November 18<sup>th</sup>, 2021  
Project No.: C228-21

**RE: Wetland Alteration Application – Town Planner Comment Revisions  
52 Goodwin Road, Kittery Point, ME  
Tax Map 58, Lot 51B**

NO.	DESCRIPTION	DATE
B	TOWN PLANNER COMMENT REVISIONS	11/18/21
A	PAPER STREET ABANDONMENT REVISIONS	10/08/21

**SITE PLAN**  
GOODWIN ROAD WETLAND ALTERATION  
52 GOODWIN ROAD, KITTERY POINT, MAINE 03905

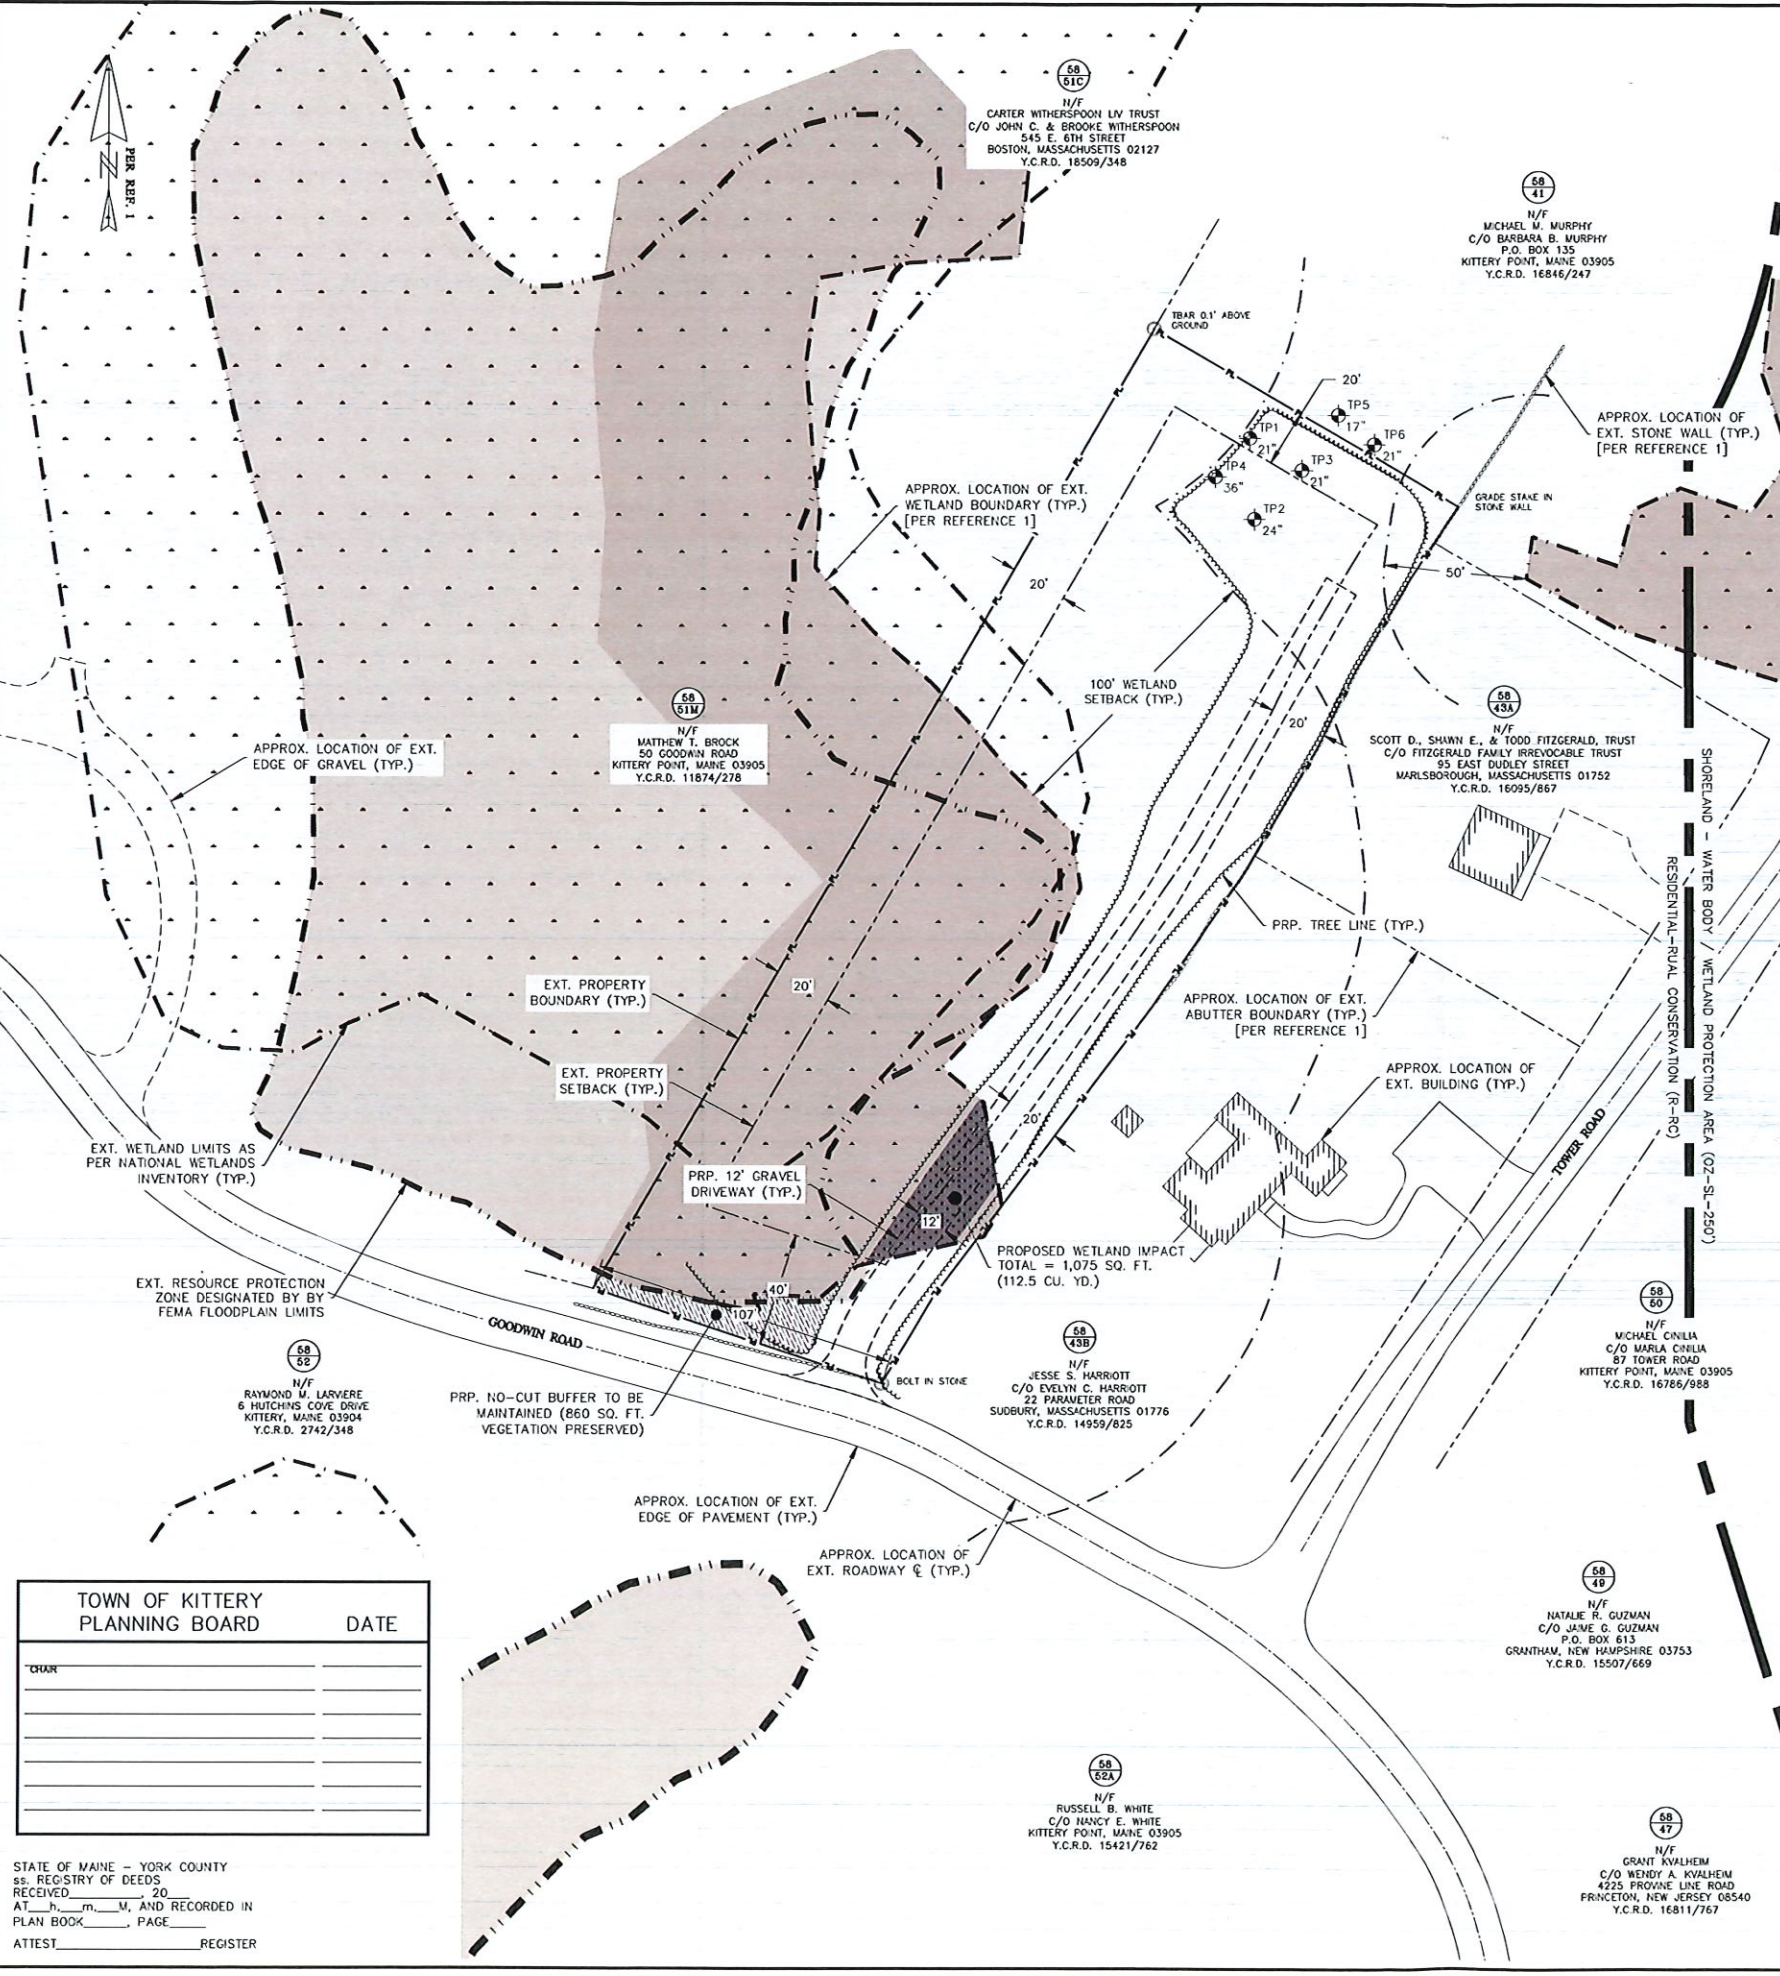
1. Plan Set Sheets 1, 2, and 4 have been updated to indicate FEMA Floodplain information. A FEMA Firmette for the project area is also attached.
2. The entire plan set has had its shading and hatchwork revised to more clearly demarcate the following sensitive areas on/near the subject parcel.

EXISTING CONDITIONS PLAN  
GOODWIN ROAD WETLAND ALTERATION  
52 GOODWIN ROAD, KITTERY POINT, MAINE 03905

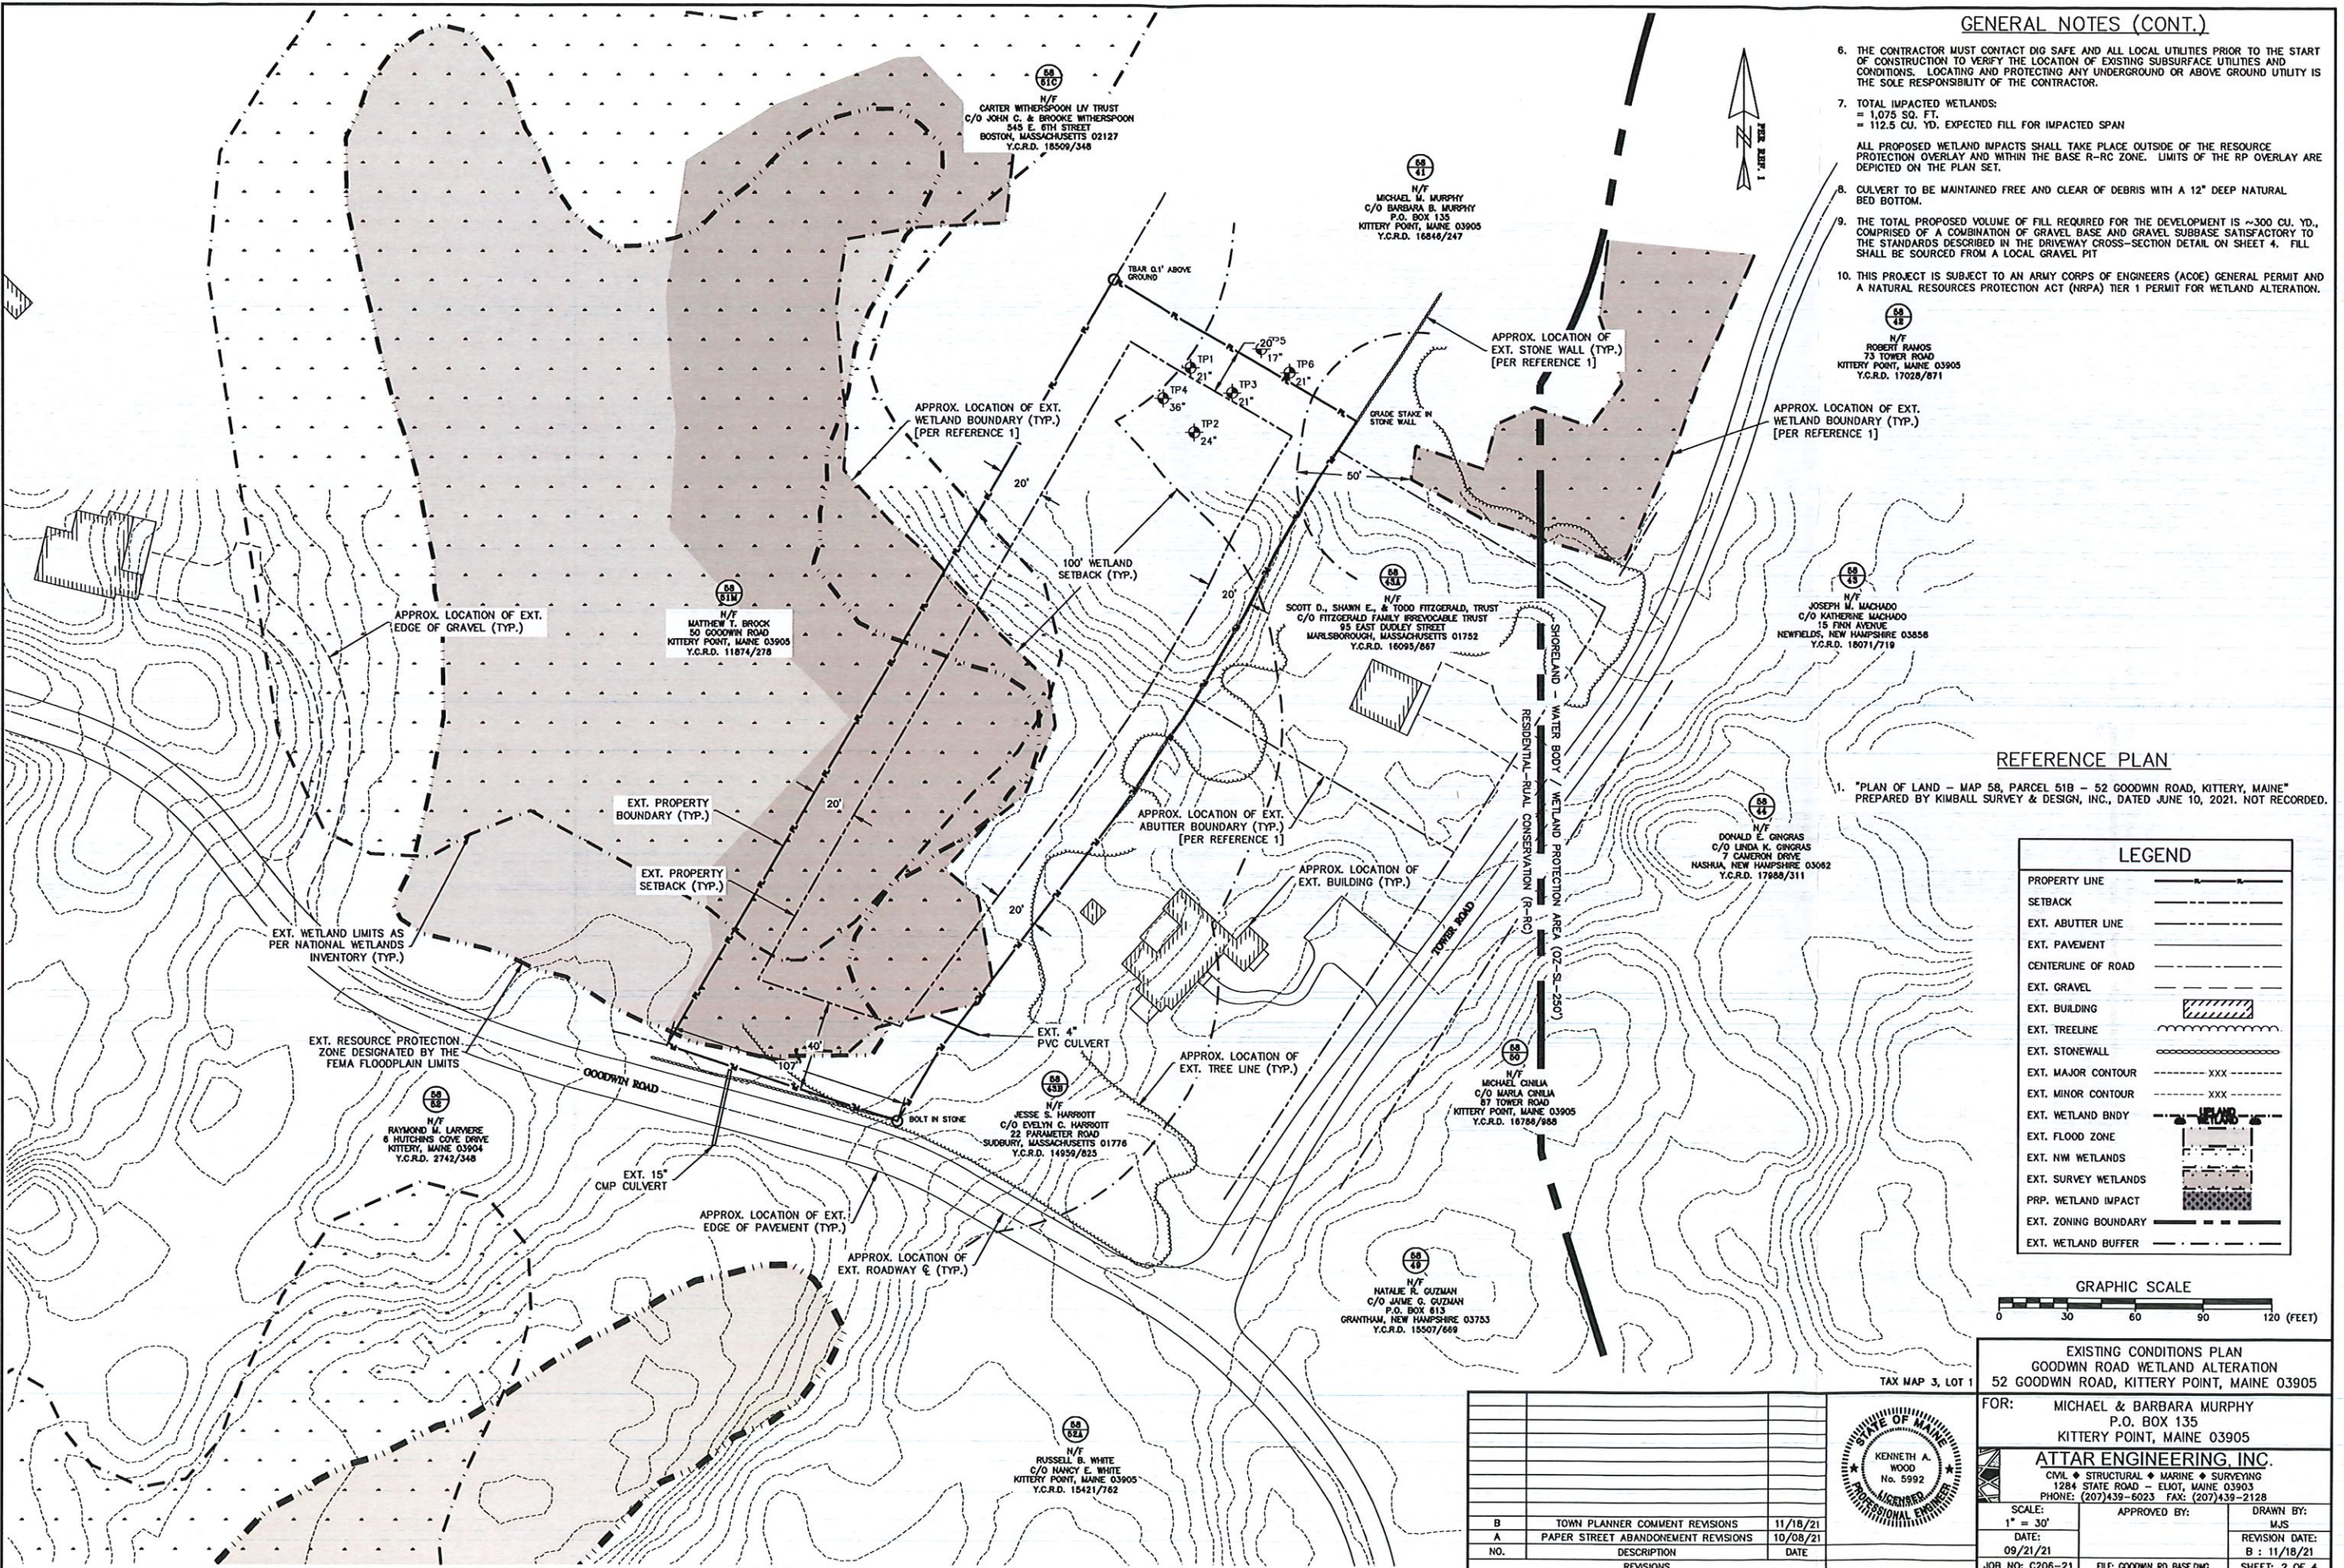
- d. Shoreland Protection Overlay
  - e. Proposed Wetland Impacts
3. General Note #7 on Sheet 2 has been revised to depict the total square footage and cubic yardage of proposed wetland impacts. Callouts to said wetland impact on Sheets 1 & 3 have been revised to also include this information.

7. TOTAL IMPACTED WETLANDS:  
= 1,075 SQ. FT.  
= 112.5 CU. YD. EXPECTED FILL FOR IMPACTED SPAN
8. ALL PROPOSED WETLAND IMPACTS SHALL TAKE PLACE OUTSIDE OF THE RESOURCE PROTECTION OVERLAY AND WITHIN THE BASE R-RC ZONE. LIMITS OF THE RP OVERLAY ARE DEPICTED ON THE PLAN SET.

9. CULVERT TO BE MAINTAINED FREE AND CLEAR OF DEBRIS WITH A 12" DEEP NATURAL BED BOTTOM.
10. THE TOTAL PROPOSED VOLUME OF FILL REQUIRED FOR THE DEVELOPMENT IS ~300 CU. YD., COMPRISED OF A COMBINATION OF GRAVEL BASE AND GRAVEL SUBBASE SATISFACTORY TO THE STANDARDS DESCRIBED IN THE DRIVEWAY CROSS-SECTION DETAIL ON SHEET 4. FILL SHALL BE SOURCED FROM A LOCAL GRAVEL PIT
